## MEMORANDUM FOR RECORD

SUBJECT: Request for a Permit Modification to the Sea Island Reserve Project, SAS-2015-00742

# SEA ISLAND CLOISTER RESERVE

PROPOSED ACTIVITY:  
BEACH RENOURISHMENT & GROIN  
CLIENT:  
SEA ISLAND ACQUISITION, LLC  
LOCATION: GLYNN COUNTY, GA.  
DATE: 9/10/15 REV: 4/2/2020 DRAWN BY: JWR SHEET: 2  
JOB NUMBER: J-25447 REVIEWED BY: CLG SCALE: 1" = 100'

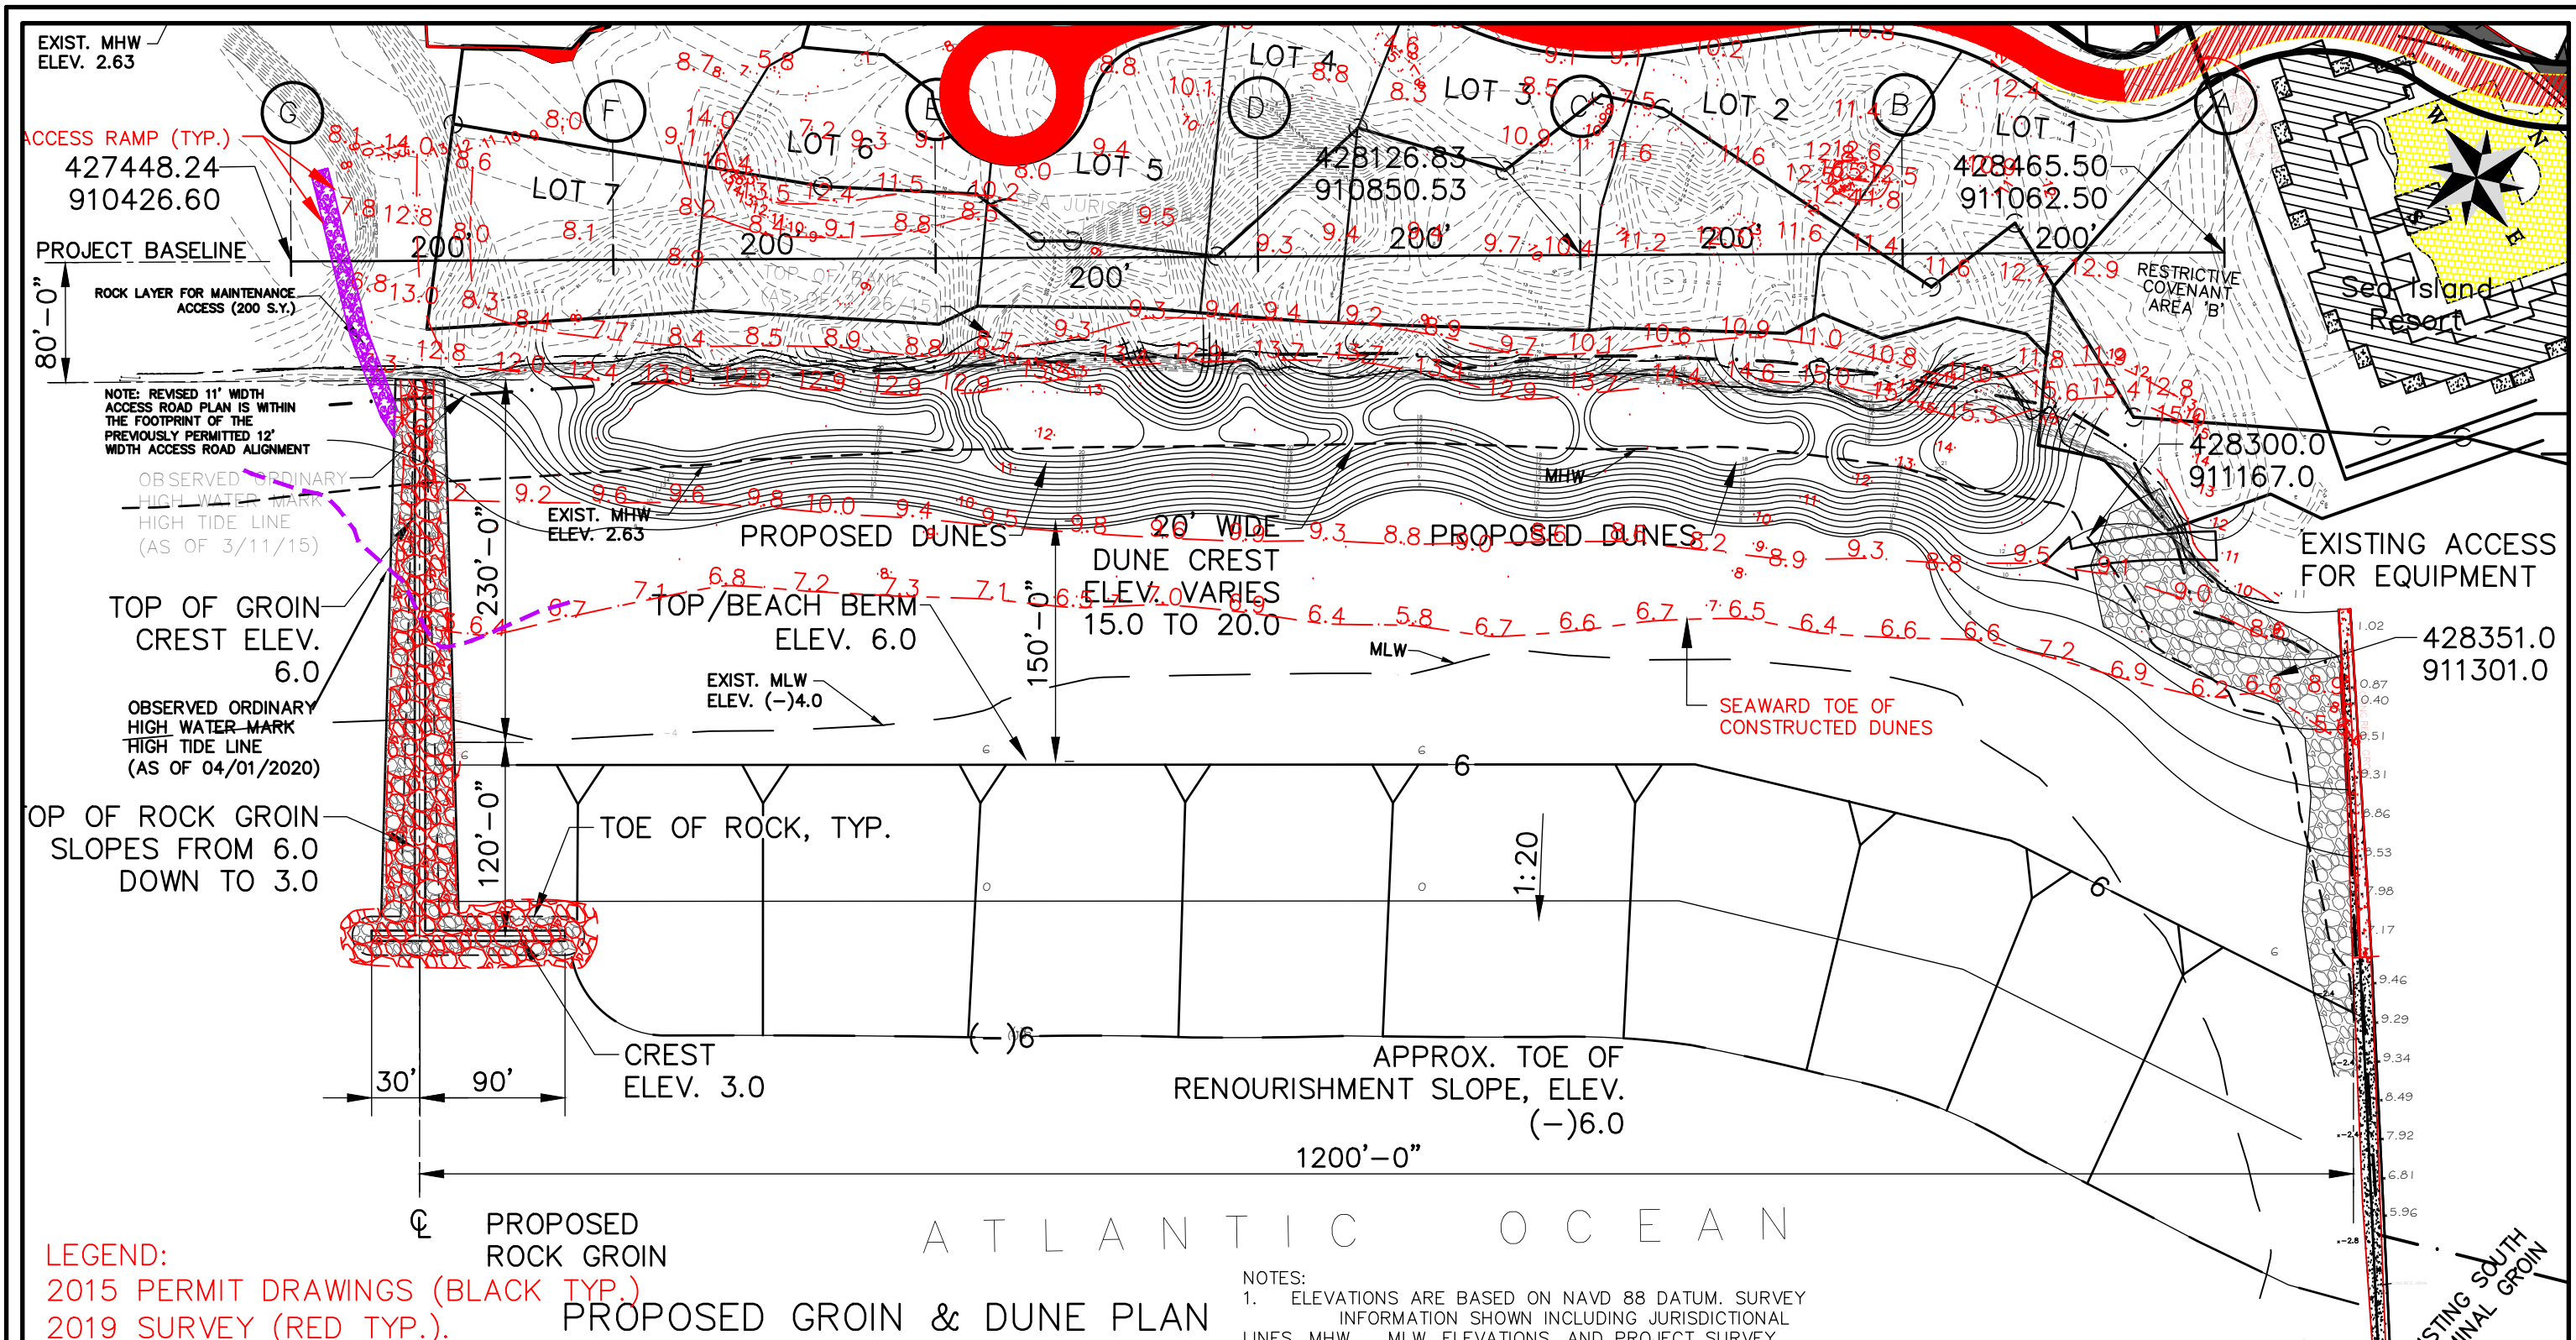
5. As authorized by Georgia CRD, the access road would be constructed within the same footprint as what is authorized in the Corps’ permit modification. However, the width of the road has been reduced from 15’ to 11’. As a result, the permittee has requested a modification to the Corps permit to reflect the change in the width of the road. Based on the 2014 delineation, a small portion of the road would be located within the Corps’ jurisdiction.

10. Based on the above information, the Corps is granting the permit modification. All General and Special Conditions issued with the 2018 permit will continue to be effective with the above referenced modification.
